Wichita-Sedgwick County Metropolitan Area Planning Department

Re: BZA2006-43: Zoning Adjustment to reduce the parking requirement by 25% and reduce the compatibility setback from 25 to 17 feet in "LC" Limited Commercial zoning, generally located north of Merton and east of Meridian (1650 S Meridian).

SITE PLAN NETCO CONSTRUCTION

SITE PLAN BCHA 2006-43

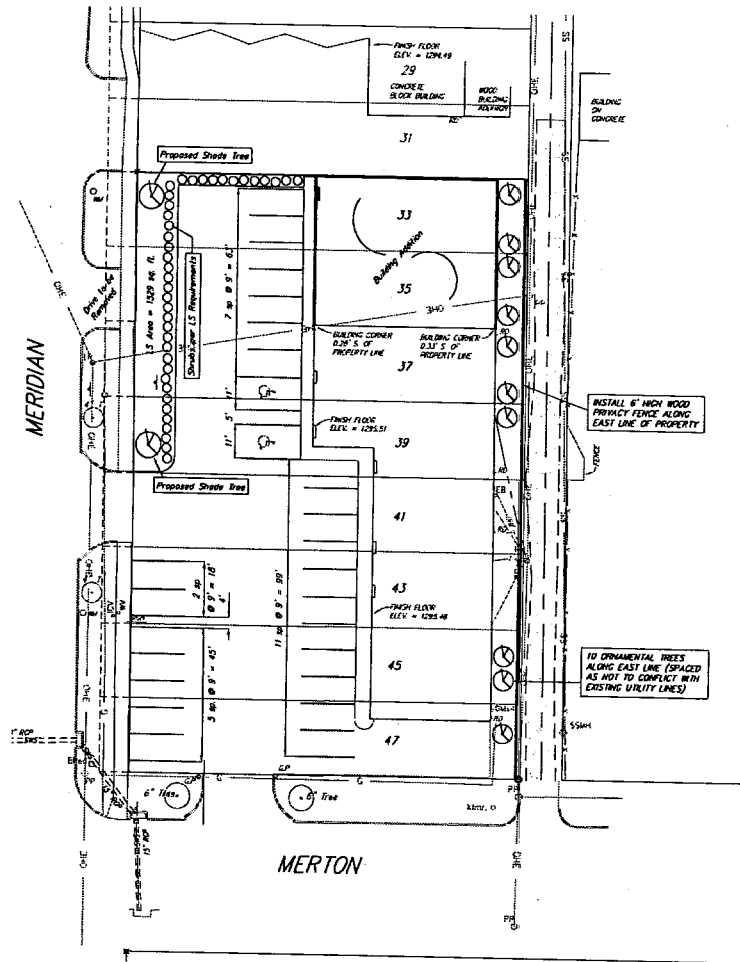
- 1) Impact on safety and convenience of vehicular and pedestrian circulation: The proposed reduction in parking requirement and compatibility setback should not have a detrimental impact on the safety and convenience of vehicular and pedestrian circulation in the vicinity of the application area. Sufficient parking should be available for the anticipated need, and the parking does not interfere with public right-of-way.

- 2) Impact on existing uses in surrounding areas: The proposed reduction in parking and compatibility setback should not impact existing uses in surrounding areas, as all parking for this project should be adequately provided on the site.

- 3) Compatibility with existing or permitted uses on abutting sites: A reduction of nine parking spaces should not compromise existing or permitted uses on abutting sites, as all parking for this project should be adequately provided on the site. The compatibility setback reduction on the site should be compatible with residences east of the site, as proposed screening and landscaping should mitigate the setback reduction.

- 4) Effect on public health, safety or welfare: There will be no encroachment into public right of way or utility easements; therefore there should be no impact on the public's safety, health or welfare.

We have reviewed your Zoning Adjustment request to reduce the parking requirement and compatibility setback on the above-referenced property. From reviewing your application we understand that you propose to construct an addition to an existing building on the site. Your site plan indicates 27 parking spaces, a 25% reduction of the 36 spaces required by the Unified Zoning Code (UZC). Your site plan also indicates a 17-foot setback from the alley centerline west of the building, an 8-foot reduction of the UZC required 25-foot compatibility setback. Therefore, you have requested a Zoning Adjustment to reduce the parking requirement to 27 spaces, and reduce the compatibility setback to 17 feet.

Our signatures below indicate that an administrative adjustment to reduce parking by nine spaces, from 36 to 27, and a compatibility setback reduction from 25 to 17 feet, is hereby granted for the aforementioned property subject to the following conditions:

- 1) The site shall be developed in general conformance with the approved site plan.
- 2) The parking area shall be paved and marked.
- 3) Any violation of these conditions shall render the Administrative Adjustment null and void.
